**Subject: Safety Recall 00V-072 NSA-11paw
(Ford Number 00S04)**

SUBJECT: Safety Recall 00S04: Certain 1999 and 2000 Model Year Explorer and Mountaineer Automatic Four Wheel Drive (A4WD) Vehicles (Excluding Vehicles With Load Leveling and/or Memory Seat Option) – Jumper Harness Installation and Multifunction Switch Replacement

RESISTOR JUMPER HARNESS INSTALLATION AND MULTIFUNCTION SWITCH REPLACEMENT

FIGURE 1

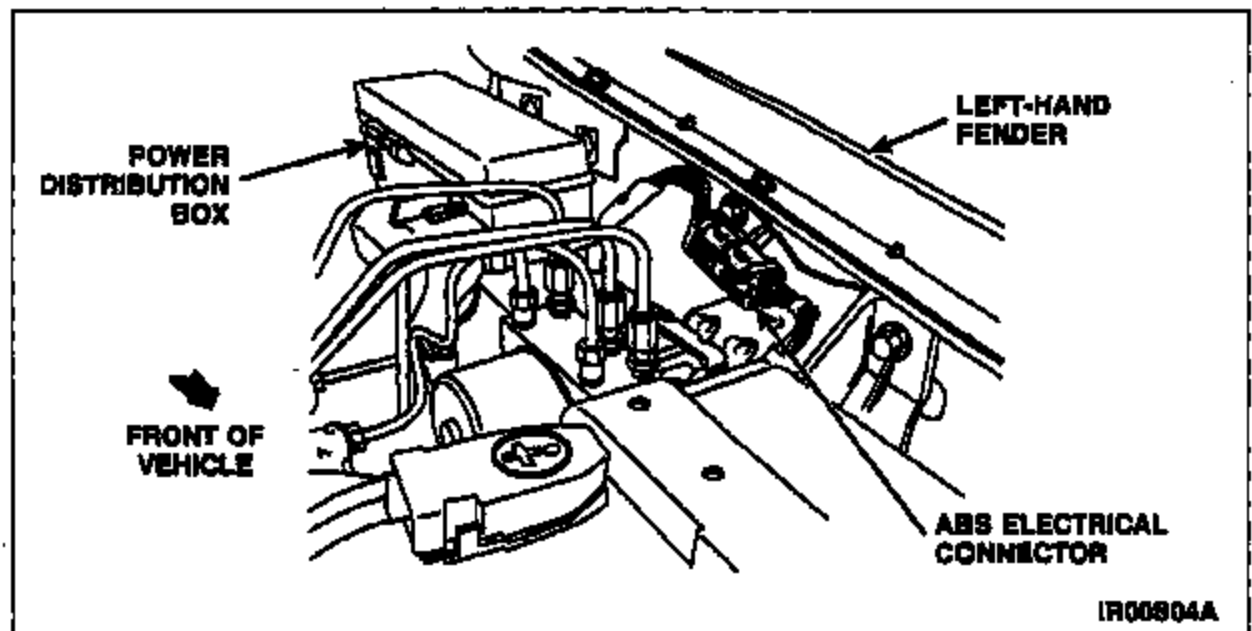
1. Record the radio stations and disconnect the battery ground cable.
2. Disconnect the ABS electrical connector located on the left-hand fender. See Figure 1.

FIGURE 2

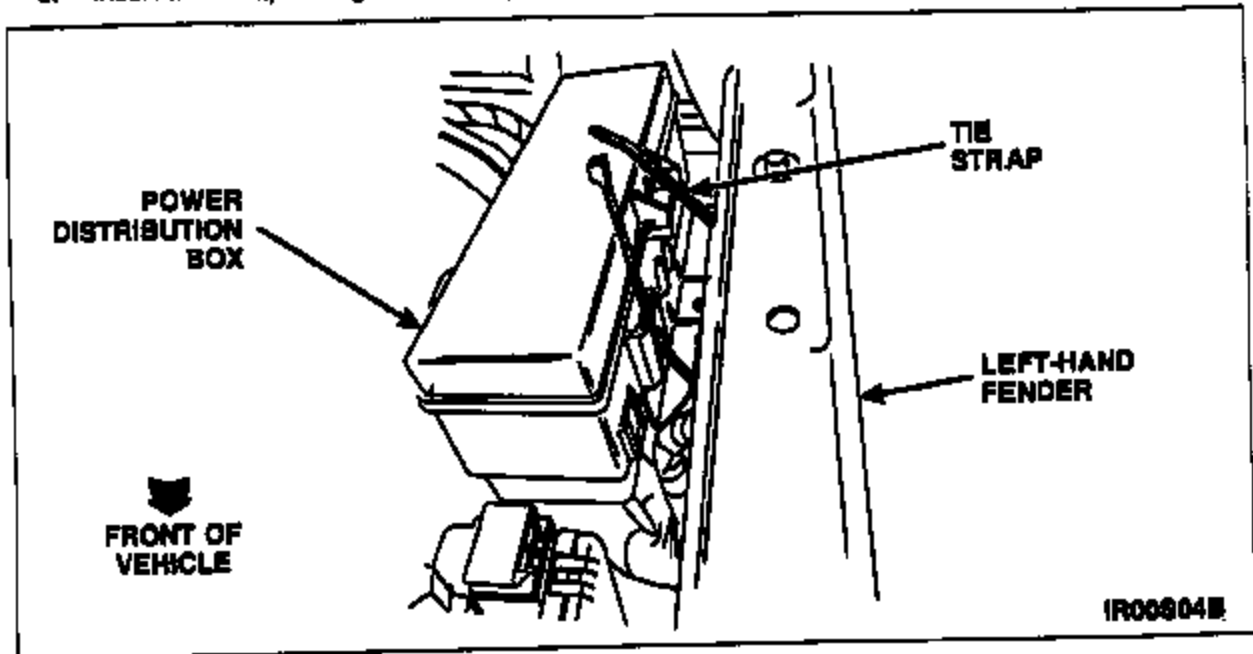
3. Insert a tie strap through the locking tab on the power distribution box. See Figure 2.

FIGURE 3

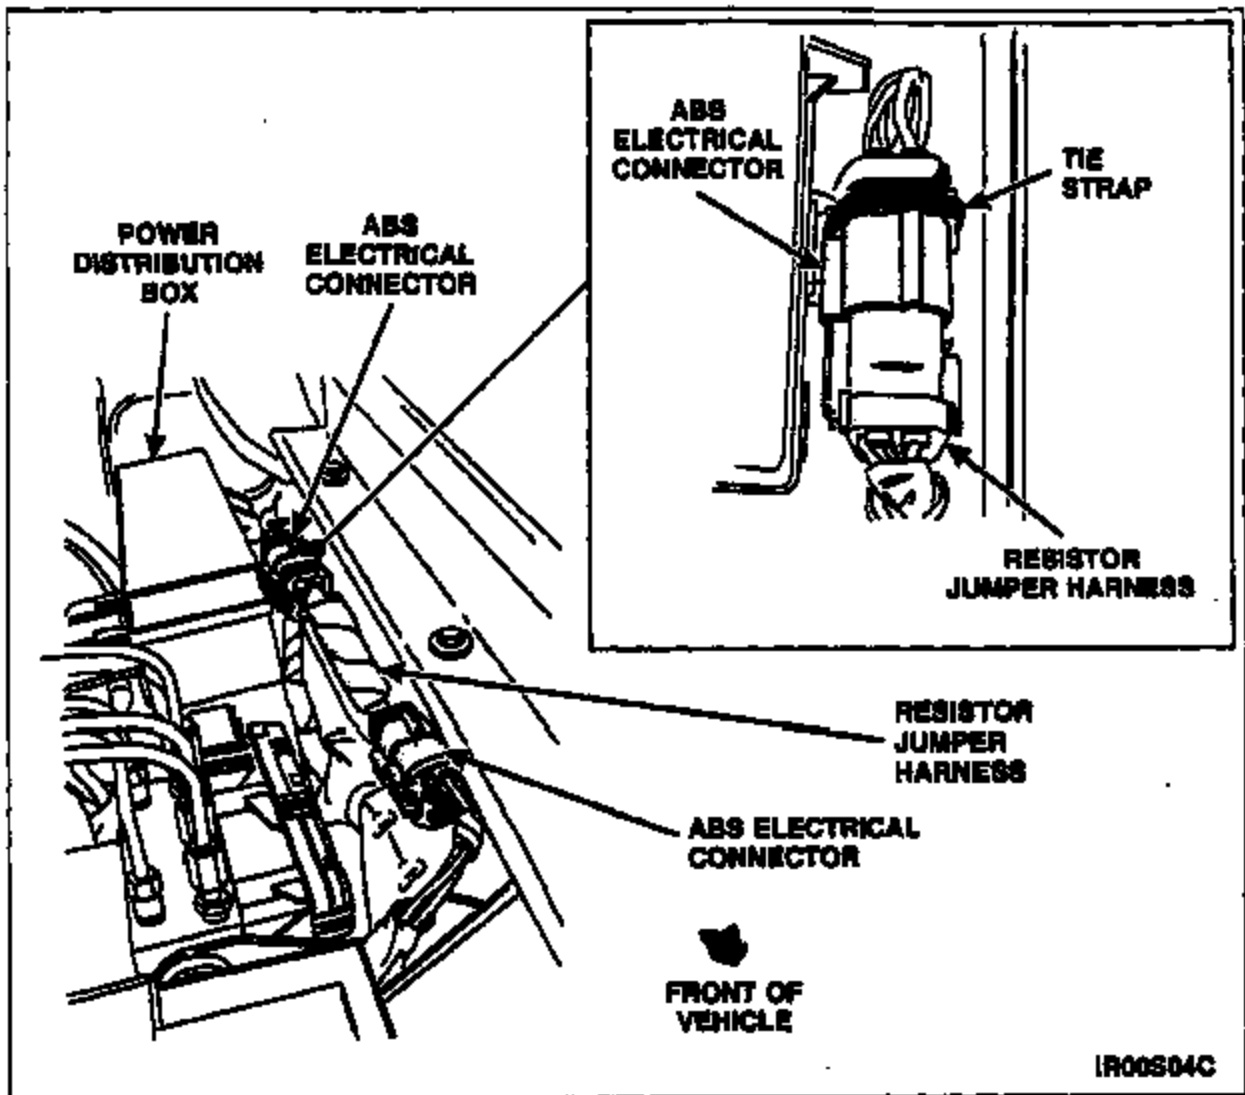
4. Connect the resistor jumper harness to the ABS electrical connector and fasten the ABS connector with the tie strap to the power distribution box. See Figure 3.

FIGURE 4

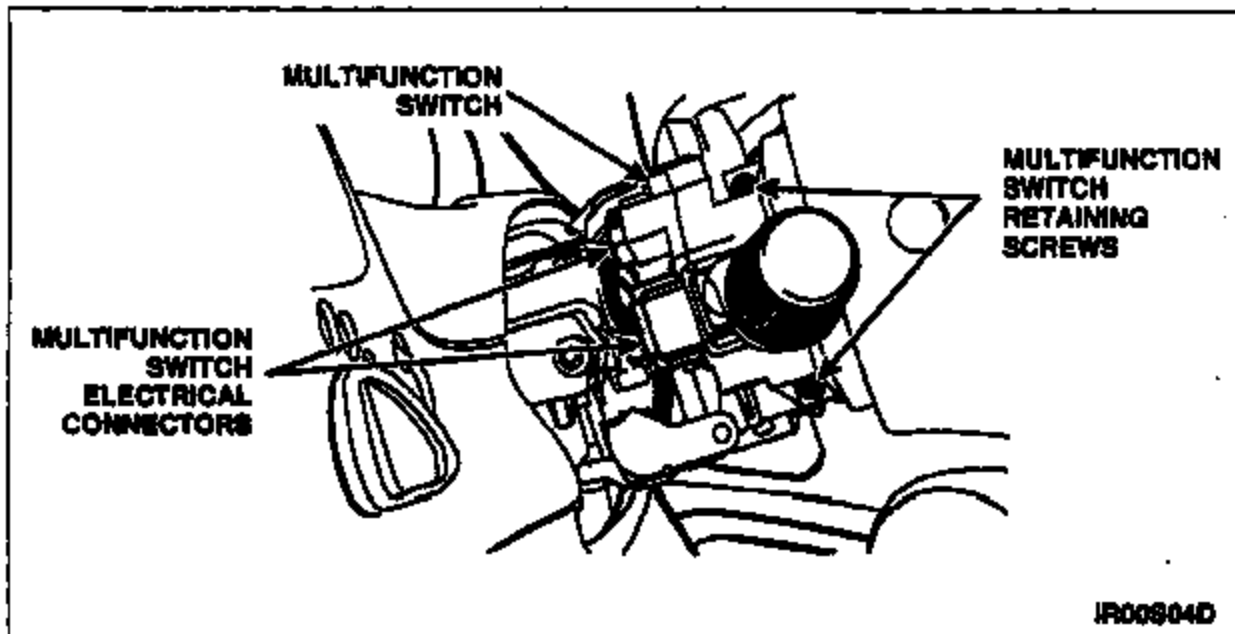
1. Turn the ignition switch lock cylinder to the RUN position. Then, push the ignition switch lock cylinder release tab with a punch while pulling out the ignition switch lock cylinder.
2. Remove the tilt wheel handle by turning the handle counterclockwise (if equipped).
3. Remove the upper to lower steering column shroud retaining screws and remove the shrouds.
4. Remove the two (2) multifunction switch retaining screws and disconnect the electrical connectors. See Figure 4.

FIGURE 5

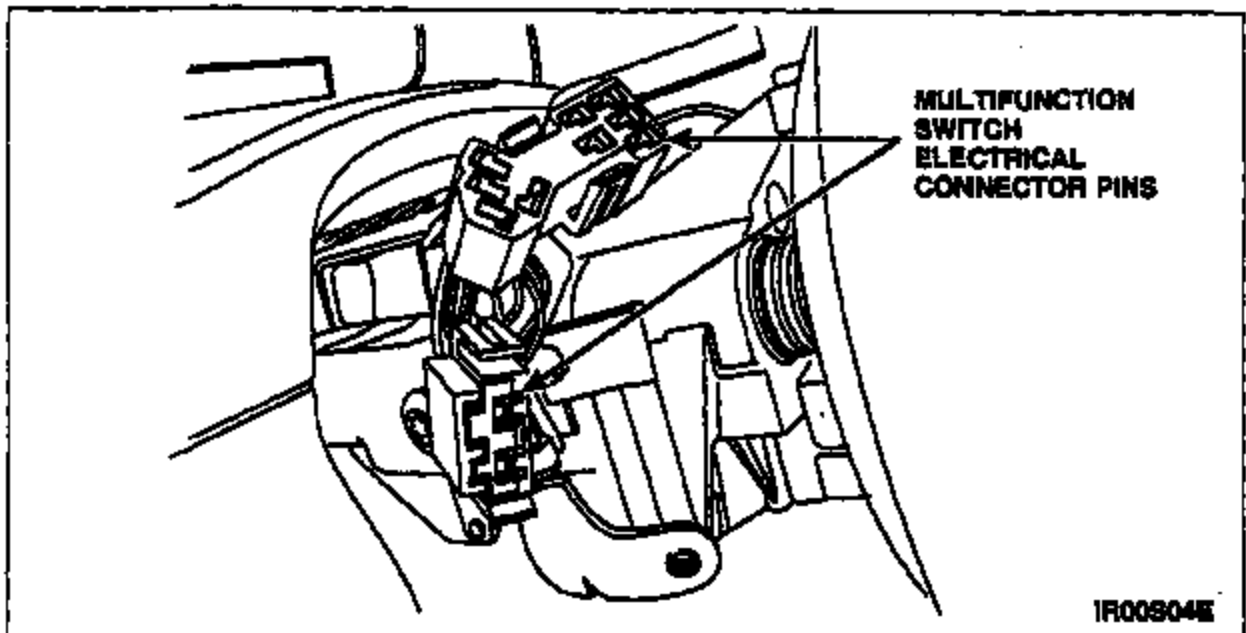
5. Inspect the multifunction switch electrical connector pins to make sure they are not loose or pushed out in the connectors. See Figure 5.
